**In the Matter of  
Water Quality Certification for the  
DeSabla – Centerville Hydroelectric Project**

**FERC Project No. 803**

**CONSERVATION GROUPS’ COMMENTS ON  
PACIFIC GAS & ELECTRIC COMPANY’S PETITION FOR RECONSIDERATION OF  
THE WATER QUALITY CERTIFICATION FOR THE  
DESABLA – CENTERVILLE HYDROELECTRIC PROJECT**

**COMMENTS OF CONSERVATION GROUPS ON PACIFIC GAS & ELECTRIC  
COMPANY’S 2011 ASSESSMENT OF FISH MIGRATION BARRIERS ON THE  
WEST BRANCH FEATHER RIVER, SPECIFICALLY IN TERMS OF THEIR  
RELEVANCE TO PG&E’S MAY 8, 2015 PETITION FOR RECONSIDERATION OF  
THE WATER QUALITY CERTIFICATION FOR THE DESABLA – CENTERVILLE  
HYDROELECTRIC PROJECT**

Figure 2: Hendricks Canal Head Gate<sup>7</sup>

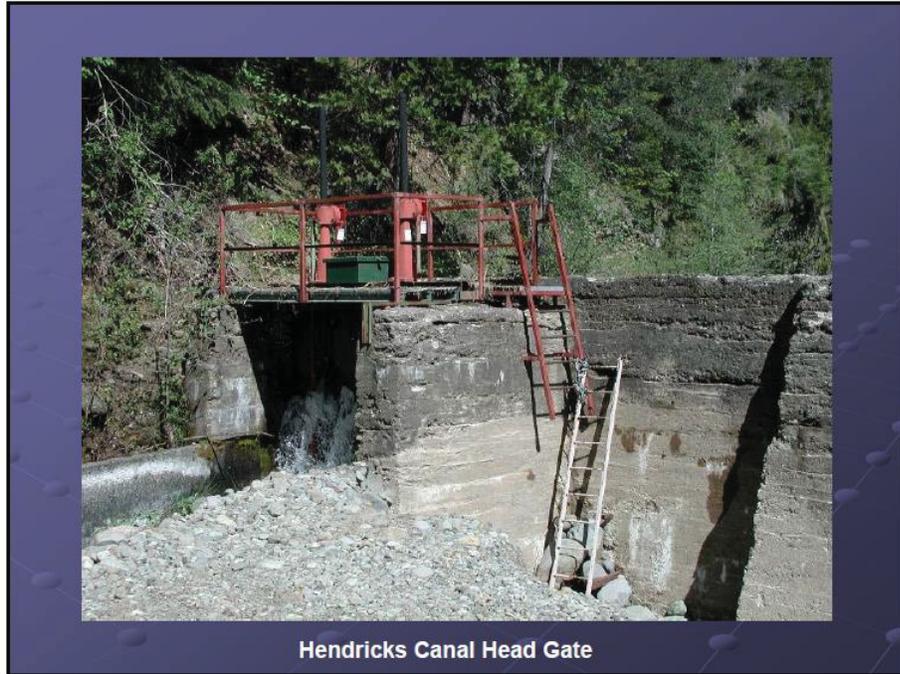
Under all circumstances, the combined works constitute a complete barrier to upstream fish passage. In addition, once fish enter the Hendricks Canal, the velocity of the water at the headworks as it enters the canal is too great to allow fish to escape from the Canal back into the river. Finally, fish that are discharged into the West Branch from the side gate in the instream flow release are unable to re-enter the Canal.

Figure 5: Plan view of Hendricks fish screen and ladder<sup>9</sup>

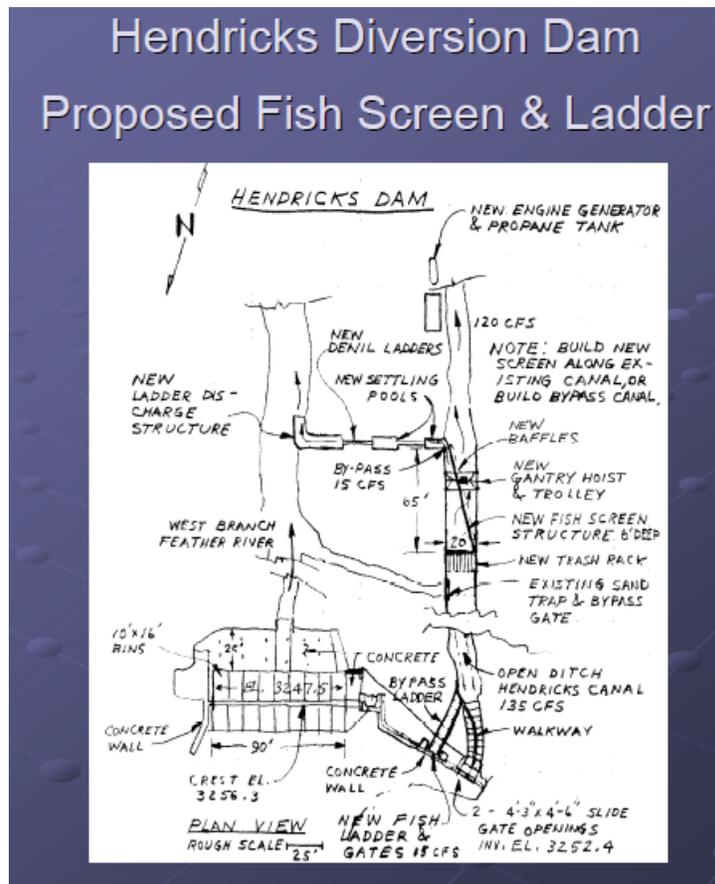
In two separate appendices to the Final License Application for the DeSabra – Centerville Project, PG&E provided drawings of a fish screen for the intake of the Hendricks Canal. In each case, the drawings show that the screen will be configured such that fish are not prevented from entering the canal. Rather, those fish that do enter the canal will be screened into the bypass flow and then discharged into the West Branch Feather River downstream of Hendricks Dam. See Figures 5, 6 and 7 below.

To our knowledge, PG&E has not modified its proposed designs for a fish screen and fish ladder at Hendricks Diversion and Hendricks Canal. PG&E has not provided additional drawings in either the FERC docket for the relicensing or to the State Board. As explained during relicensing, the absence at relatively lower flows of water flowing past the intake makes a more conventional screen design, which would keep fish out of the Hendricks Canal altogether, ineffective.
